Tompkins Cottage Orcas Island, WA

APPROVED TO CONSTRUCT
PER STATE BUILDING CODES
AS REQUIRED BY RCW 19.27.031
SUBJECT TO FIELD INSPECTION
AND CORRECTION

PERMIT SET

1 FLOOR PLAN REVISED 05-23-2011
SCALE 1/4" = 1'

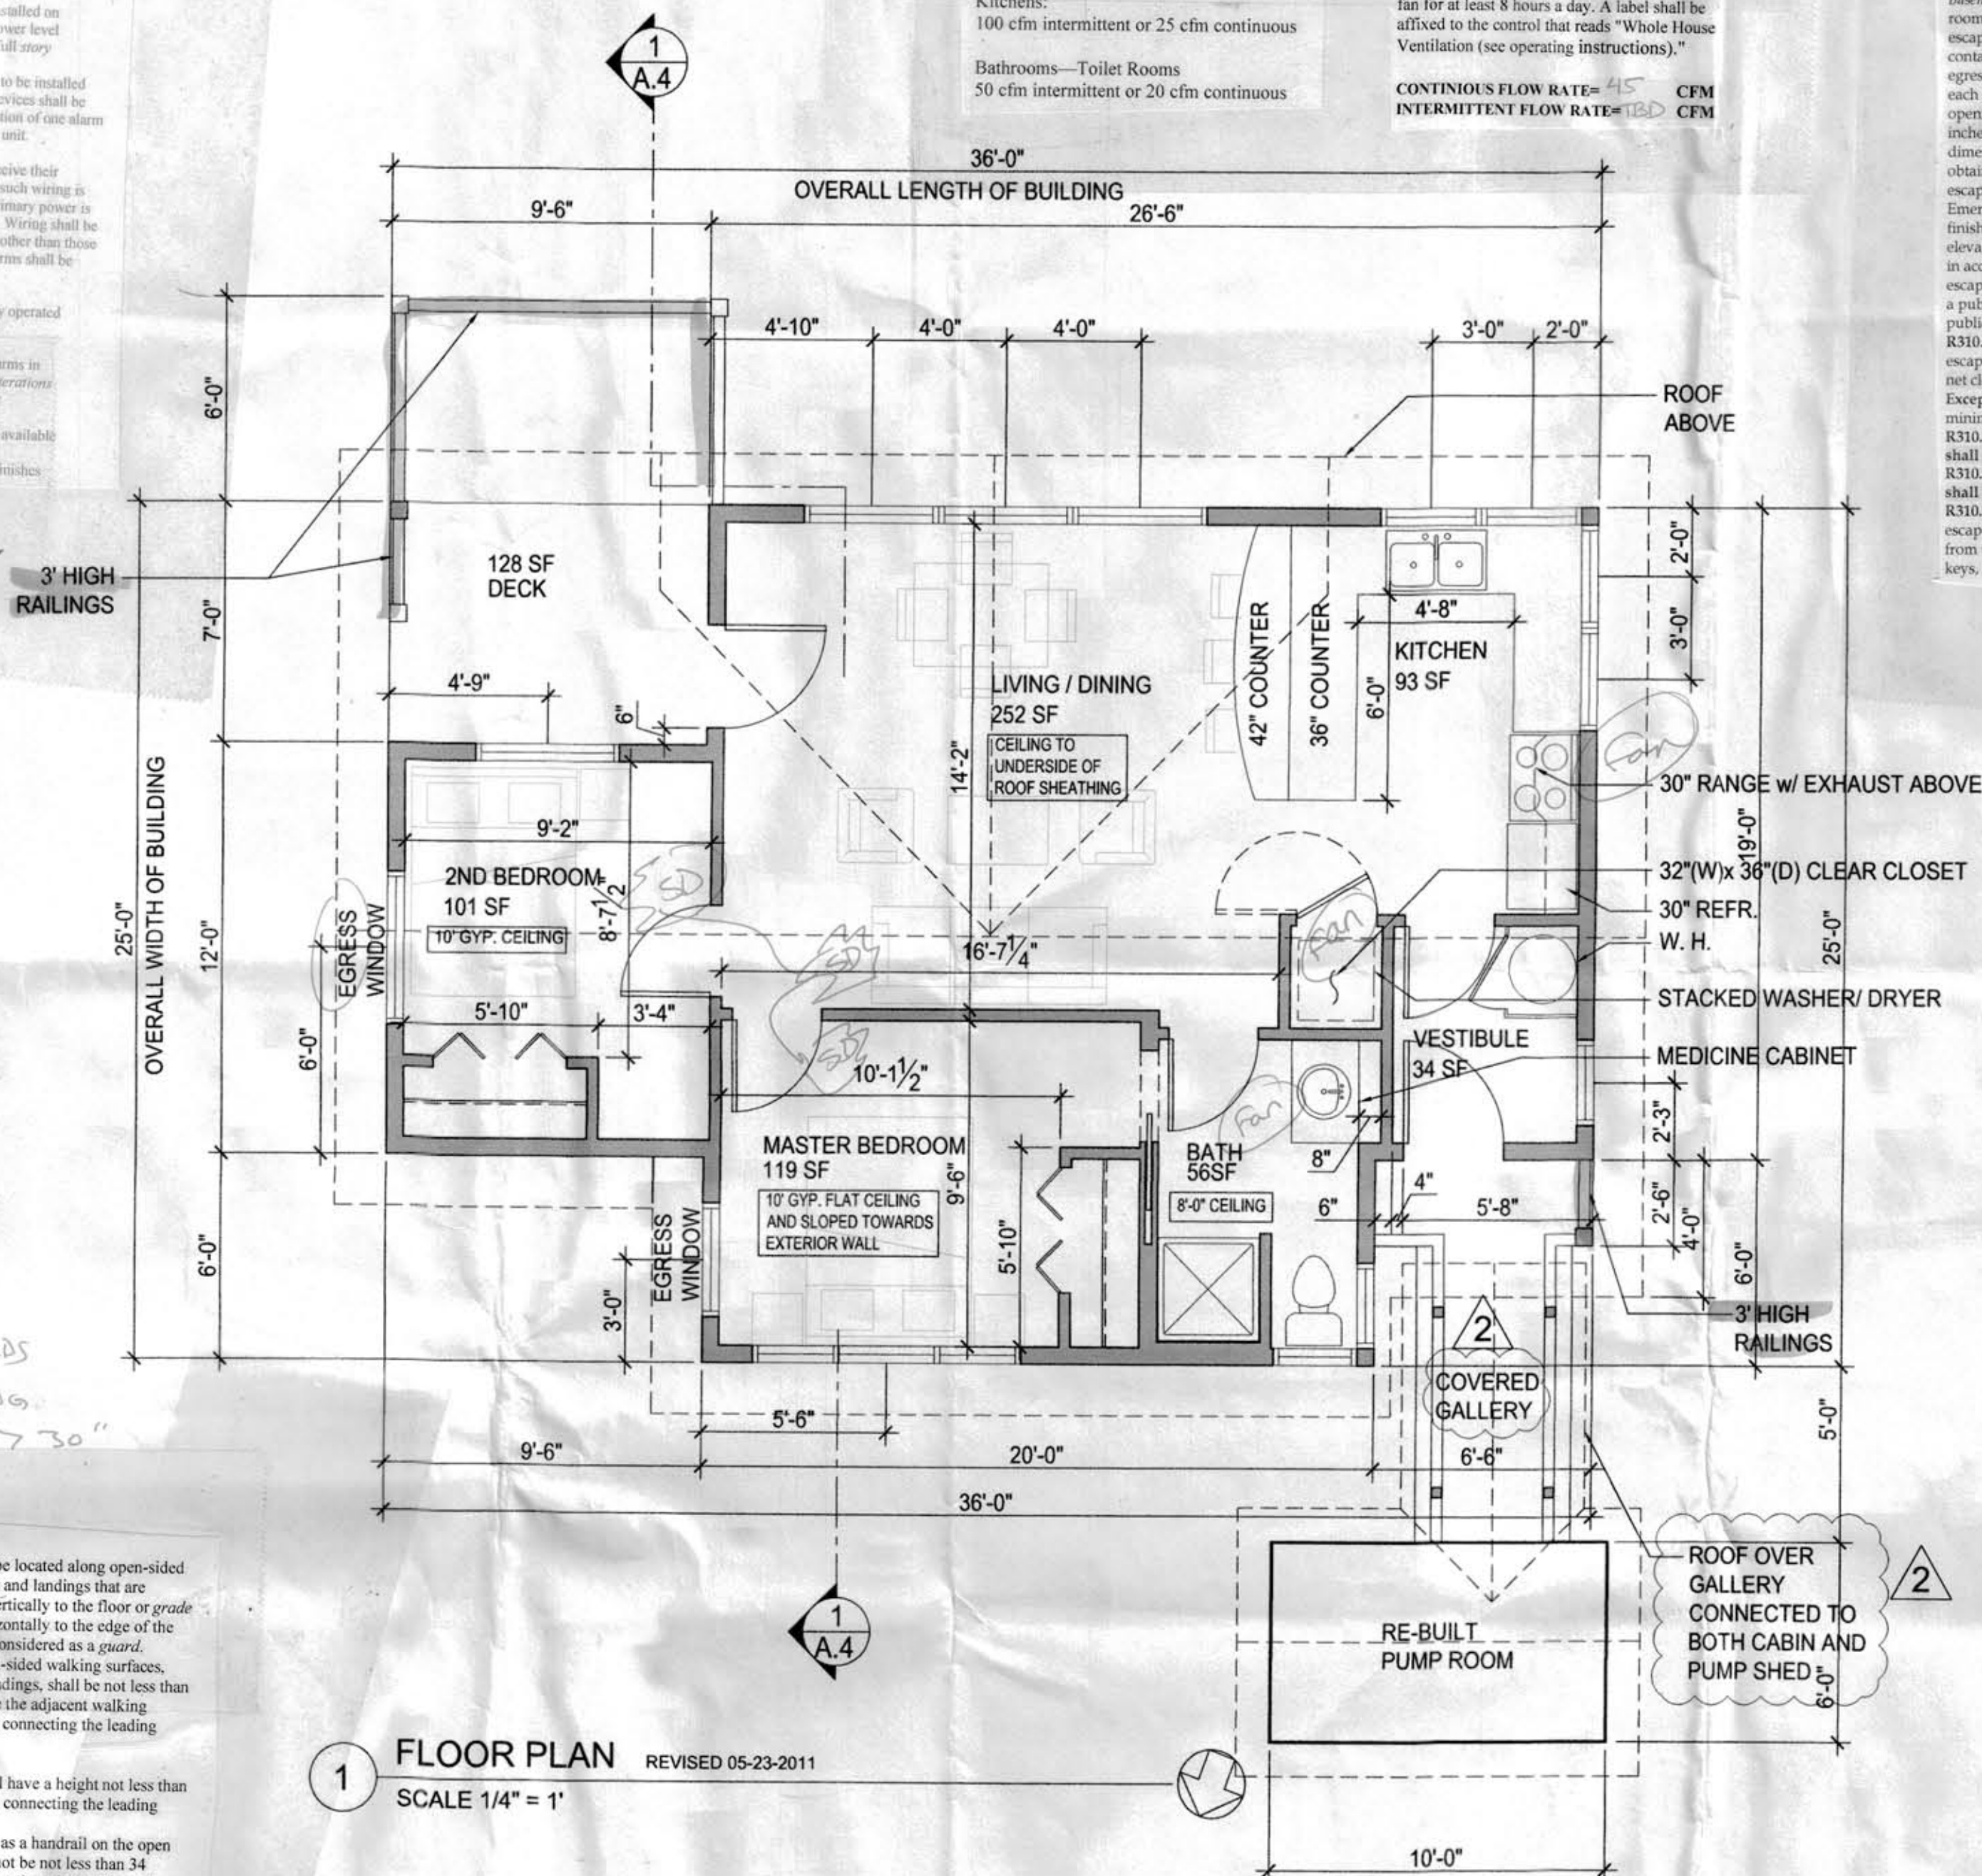
FAU NOTES

EGRESS,
EVERY
BEDROOM

RAILING/GUARDS
WHEN WALKING
SURFACE IS 7'30"
ABOVE GRADE

ROOF FRAMING PLAN
SCALE: 1/4" = 1'-0"

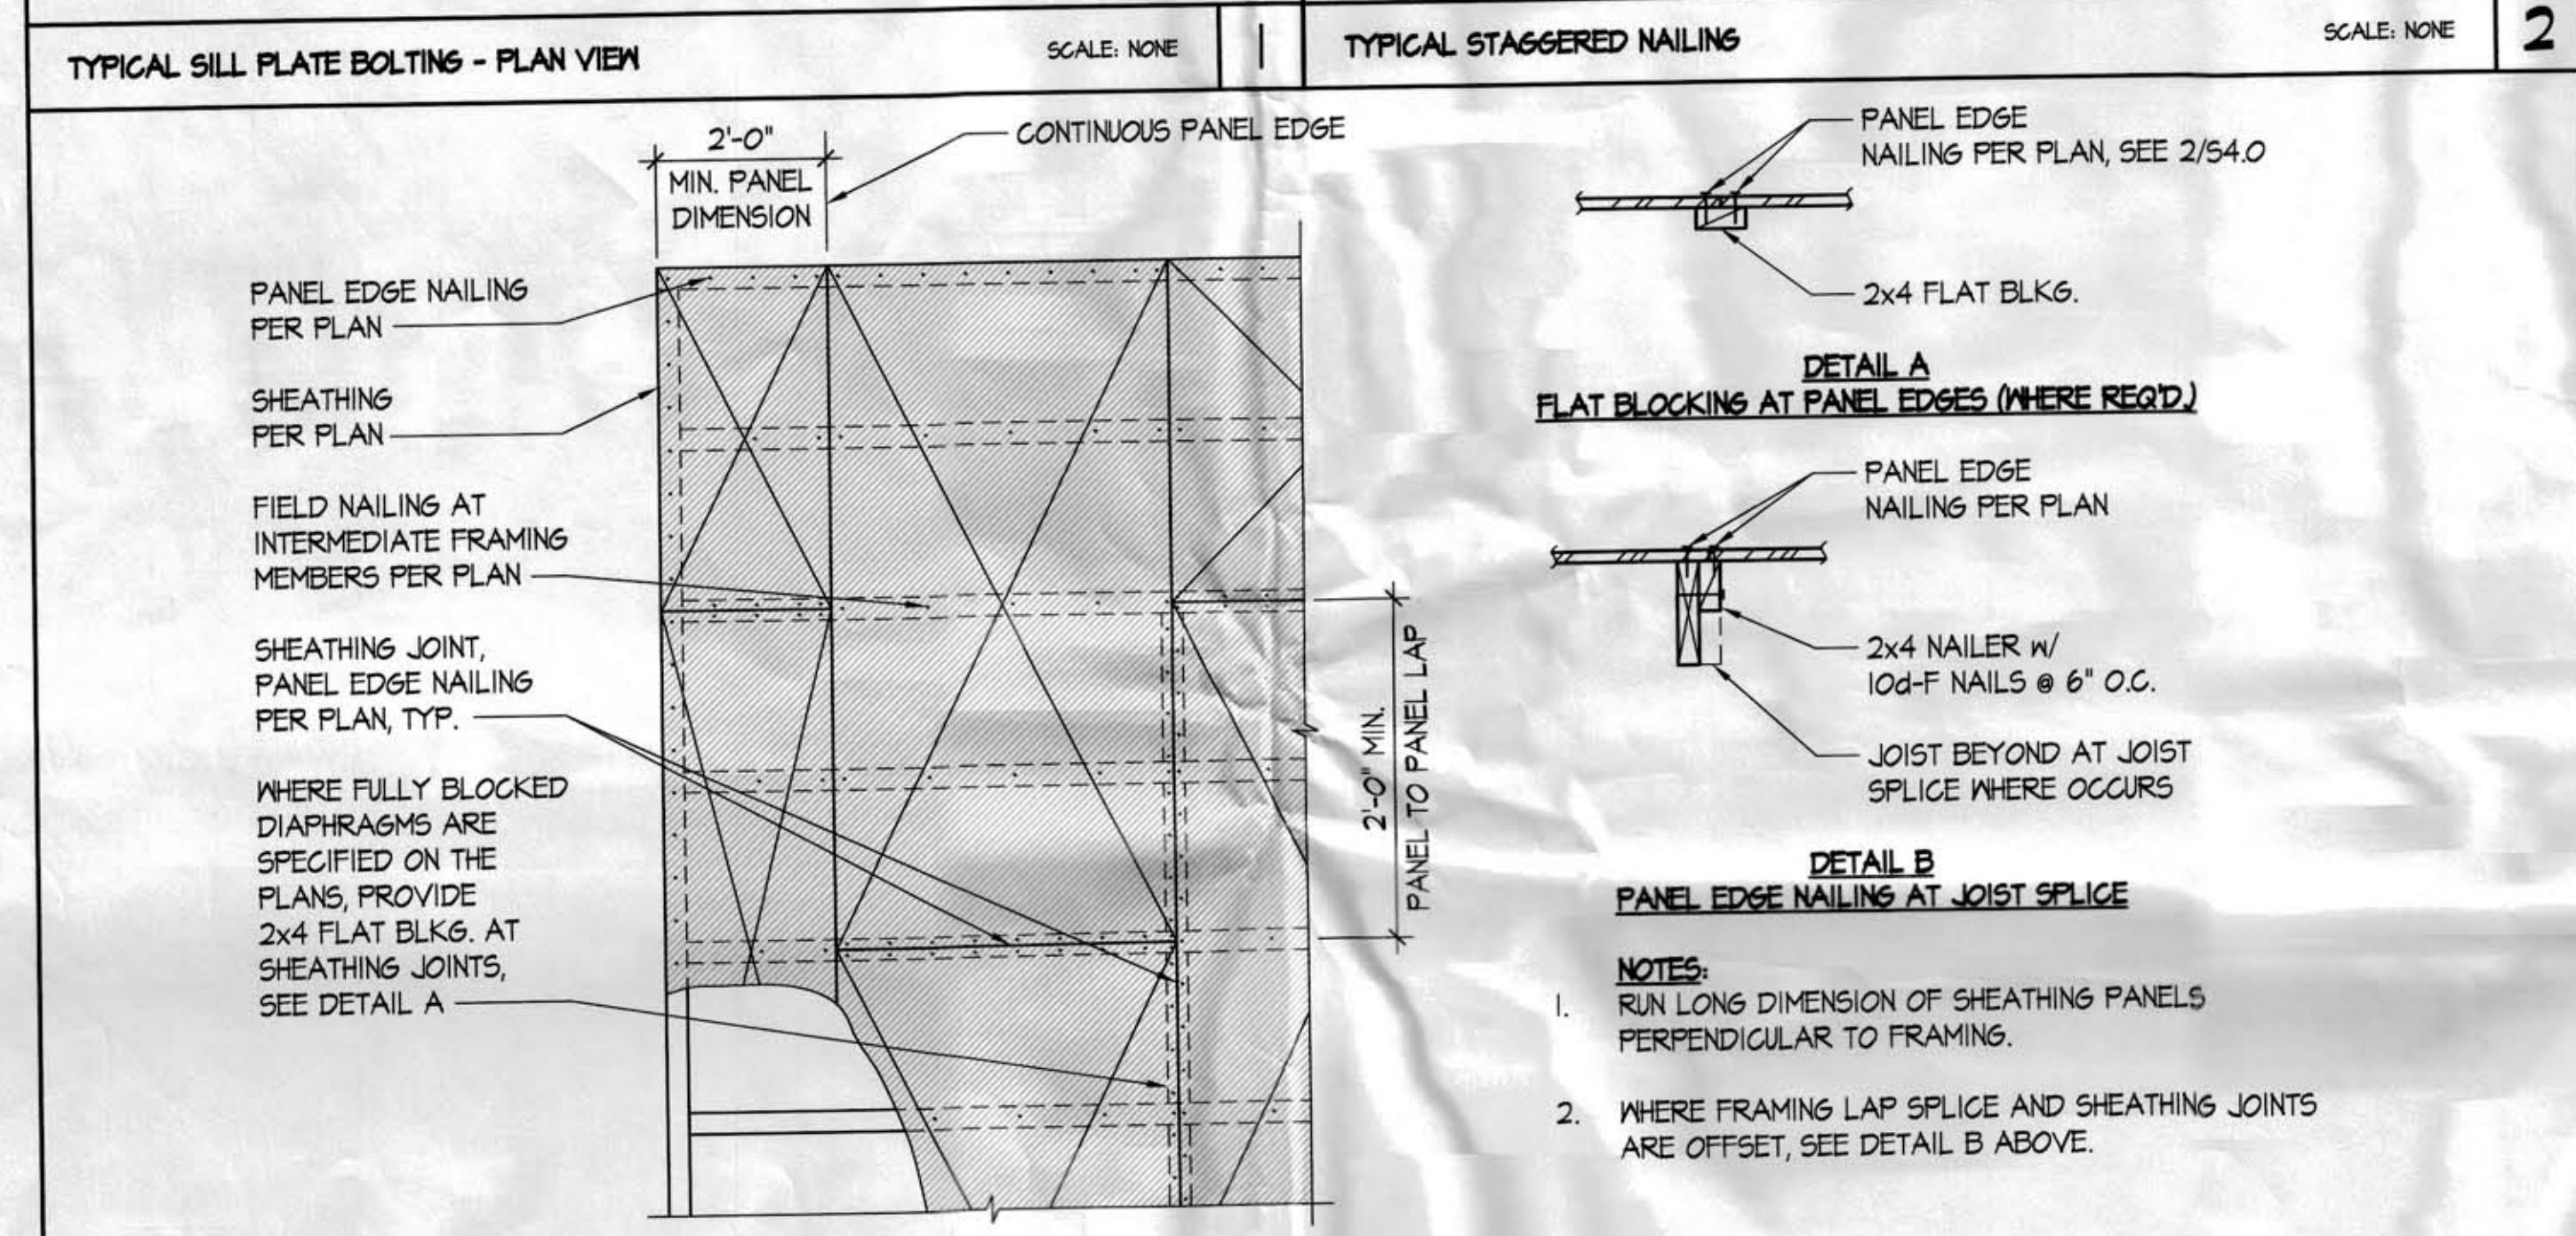
PROVIDE TRUSS SPECS @ FRAMING
